**JONES COUNTY  
PLANNING & ZONING COMMISSION  
TUESDAY, OCTOBER 22, 2024 4:30 P.M.  
COMMUNITY ROOM, JONES COUNTY COURTHOUSE**

Re: Review of Barner Second Addition subdivision-preliminary and final plats

# Preliminary Plat Barner Second Addition to Jones County

# Final Plat Barner Second Addition to Jones County

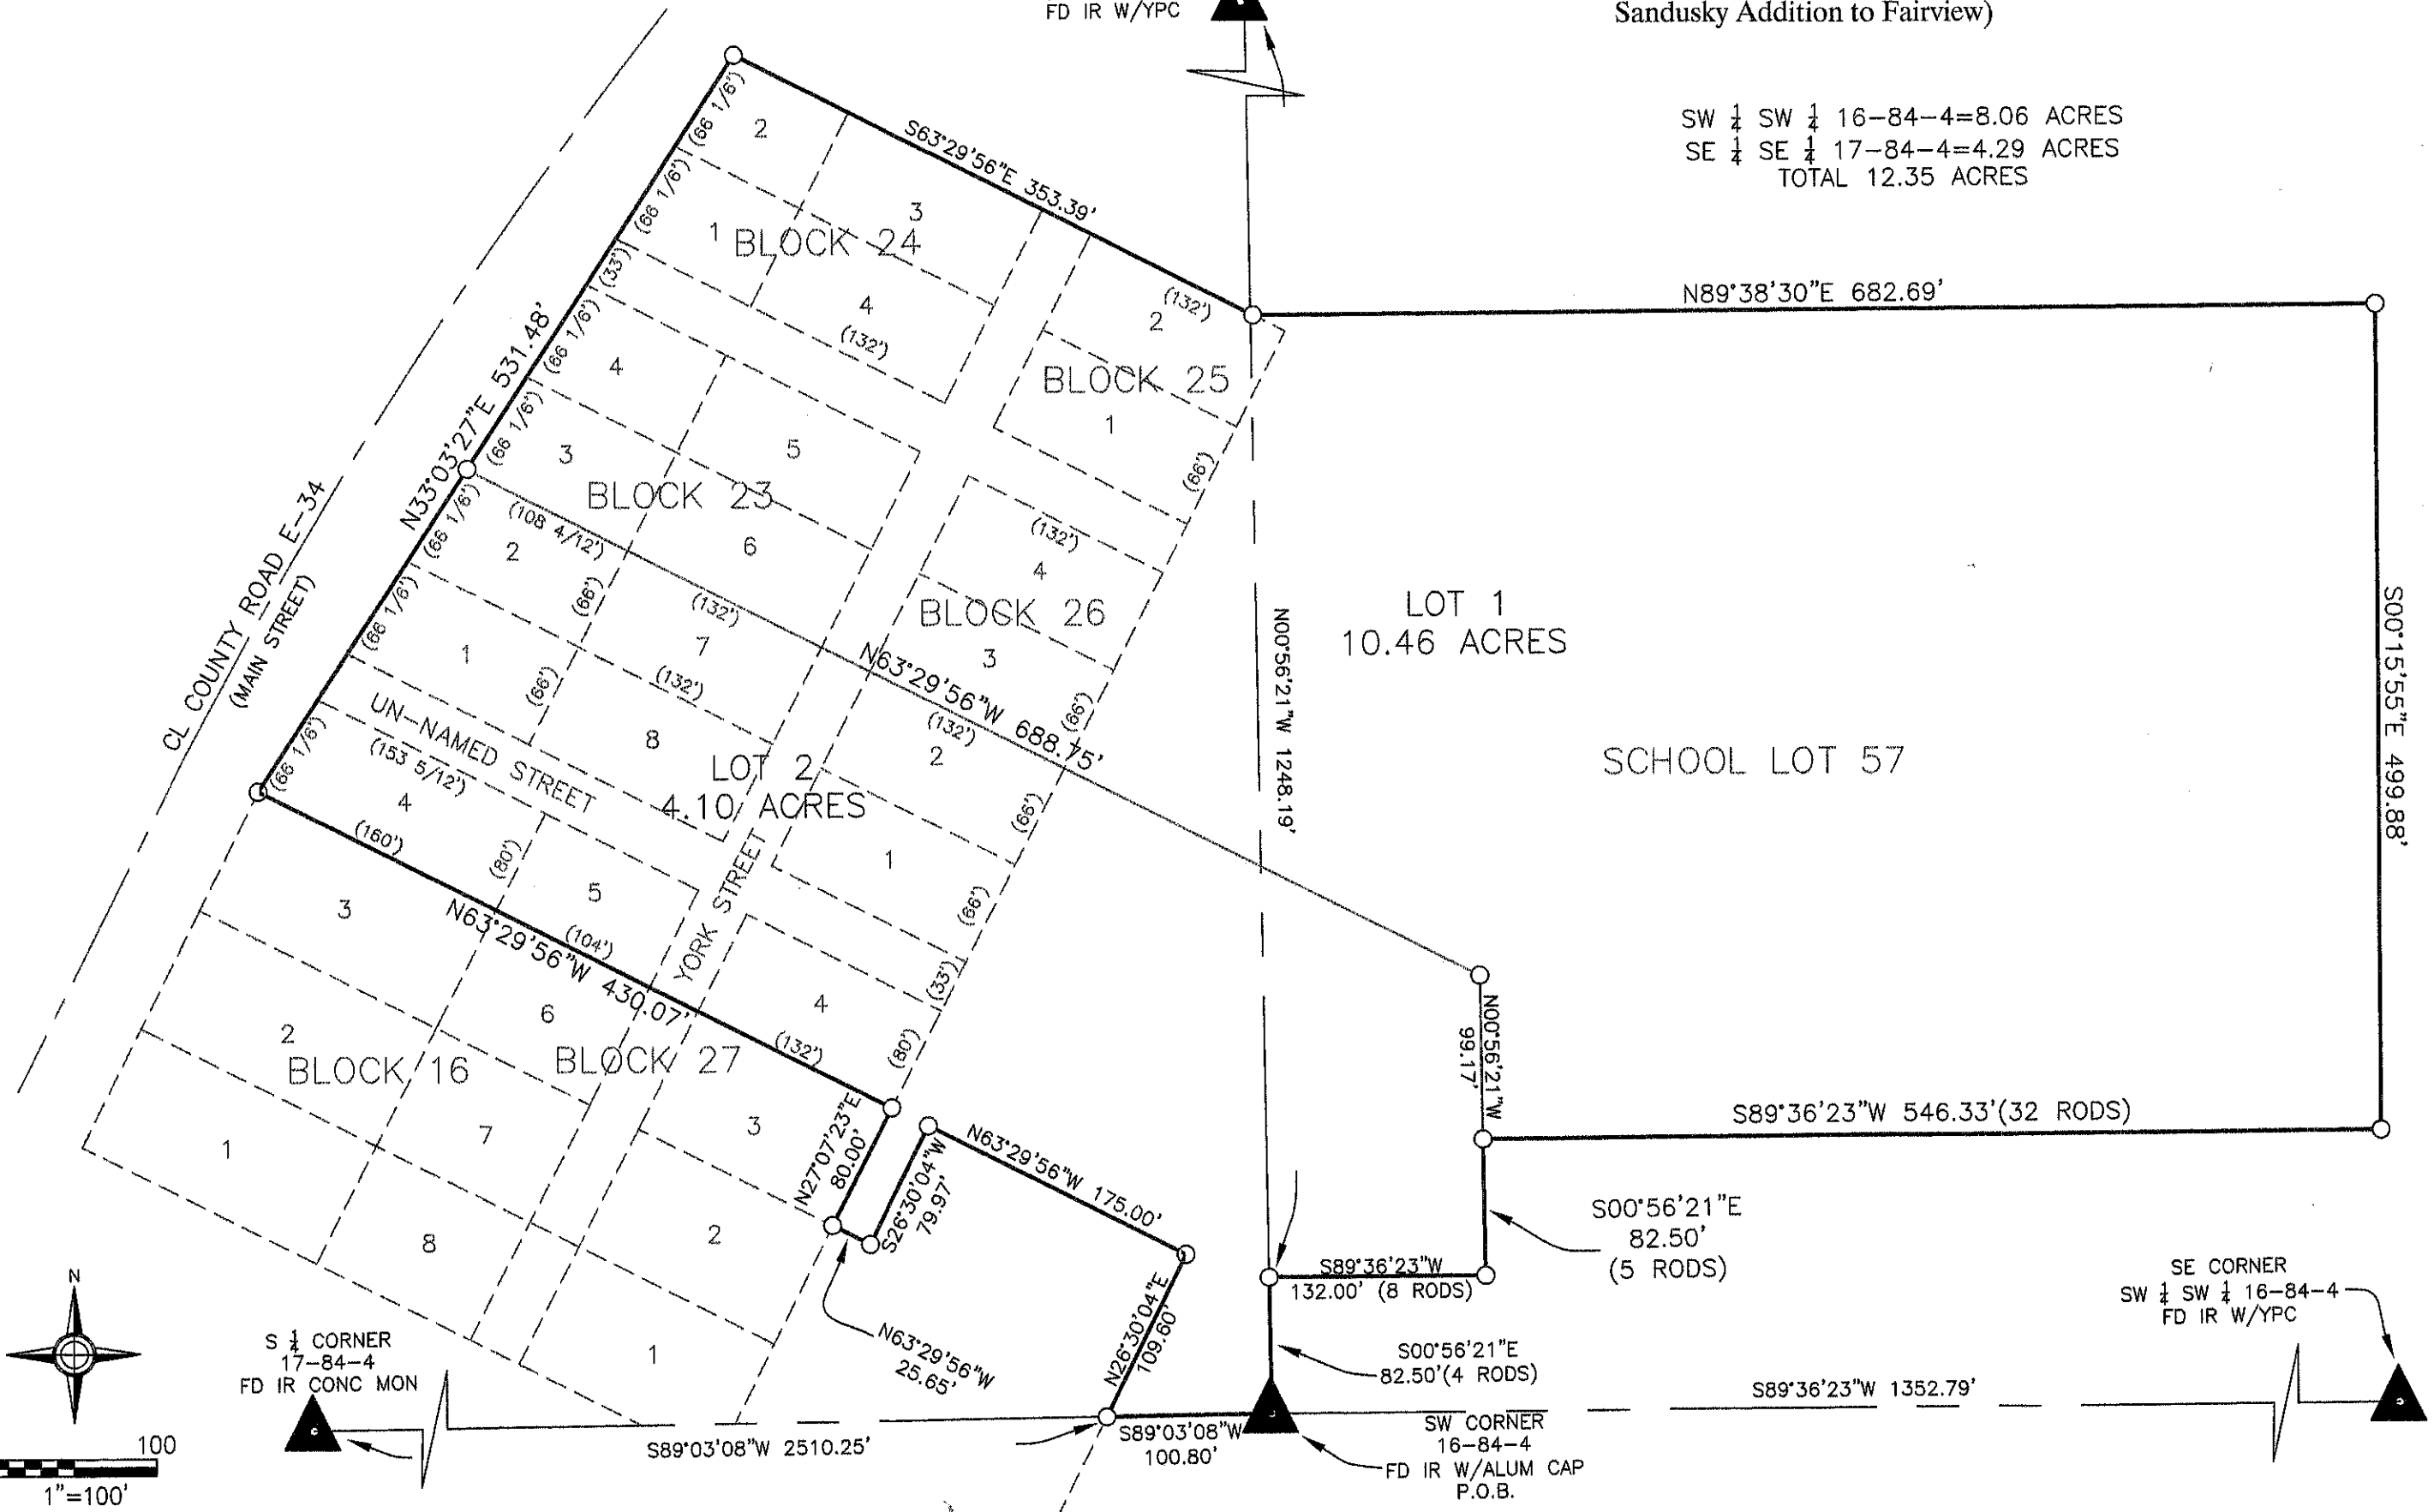
Jones County Engineer – Derek Snead
Comments:	<p>I have reviewed the Preliminary and Final Plats for the Barner Second Addition to Jones County in Section 16 and 17 of Fairview Township. My comments are as follows:</p> <ul style="list-style-type: none"> <li>• Jones County has established rules for control of access to secondary roads. This policy was developed to formalize Jones County’s requirements for the location and establishment of driveways, field accesses and farm entrances requested by county property owners. If a new access will be constructed or if there are any proposed changes to an existing property access, the property owner must file an ‘Application for Access’ with the Jones County Secondary Road Department prior to commencing any access construction.</li> <li>• Jones County has established an ordinance to ensure uniform building and structural alterations along County public secondary road rights-of-way that will protect and preserve the highway corridor. If a property owner desires to build a structure or alter an existing structure that is within thirty feet of the secondary road right-of-way, then a variance request must be filed with the County Engineer’s Office before any construction may commence.</li> <li>• Any work that may necessitate work (ditching, driveway resurfacing, etc.) within the County road right-of-way must first obtain an Application for Alteration of Public Right-of-Way before commencing with construction.</li> </ul> <p>If the applicant has any questions on any of the above conditions, please contact myself for more information and guidance.</p>

Jones County Conservation Board - Brad Mormann
Comments:	No comments received
	Jones County E911 Coordinator – Gary Schwab
Comments:	The Barner Second Addition Preliminary and Final Plats have been reviewed and have been found compliant to Chapter 3, Uniform Rural Address System to Title IV Streets, Roads Public Ways and Transportation, as part of the Jones County Code of Ordinances.
	Land use Administrator- Whitney Amos
Comments	According to the plat of survey there are no entrances to Lots 1 or 2. There are also no utility easements on the plat of survey.
